Office Action Summary

09/899,530

KOJIMA ET AL.

DETAILED ACTION

FIG.16

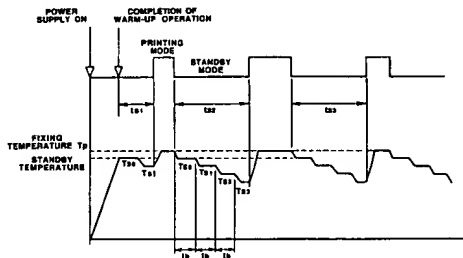
- {claim 1} An image-forming device (column 1, lines 8-12) comprising: a heating device (column 1, lines 29-30); a control device which controls the heating device by on/off control (column 1, lines 29-47), and alters a period of on/off control in accordance with control modes (figure 16, reference Printing Mode, Standby Mode, ts1, ts2, ts3), the control modes including a printing mode for maintaining the heating drum at the predetermined temperature during image-formation (figure 16, reference printing mode; column 1, lines 31-38), and at least one ordinary mode which is used at times other than during image formation (figure 16, reference standby mode; column 1, lines 31-38), wherein, if a period of on/off control of the printing mode is T1 and a period of on/off control is T0, then $T1 < T0$ (figure 16, reference Printing Mode, Standby Mode, ts2)

- {claim 2} standby mode (column 1, lines 31-38); pre-heating mode (figure 16, reference Ts1, Ts2, Ts3; column 1, lines 57-60; column 2, lines 7-10) ; if the period of on/off control of the printing mode is T1, a period of on/off control of the standby mode is T2 and a period of on/off control of the pre-heating mode is T3, then at least one of the

following relationships: $T1 < T2$ and $T1 < T3$ is satisfied ($T1 < T3$; figure 16, reference Ts1, Ts2, Ts3)

- {claim 7} when image formation has finished, the printing mode is deselected and the standby mode is selected (figure 16, reference Printing Mode, Standby Mode)

- {claim 8} if the standby mode is selected and no image-formation is performed for a predetermined period of time, then the pre-heating mode is selected (figure 16, reference Ts0, Ts1)

- {claim 9} in the pre-heating mode, the heating drum is maintained at a temperature lower than the predetermined temperature (figure 16, reference Ts0, Ts1)

FIG.1

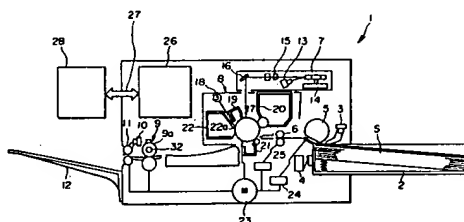
- {claim 5} the control device alters a duty ratio of on/off control in response to a difference between a current temperature of the heating drum and the pre-determined temperature (column 1, lines 42-47)
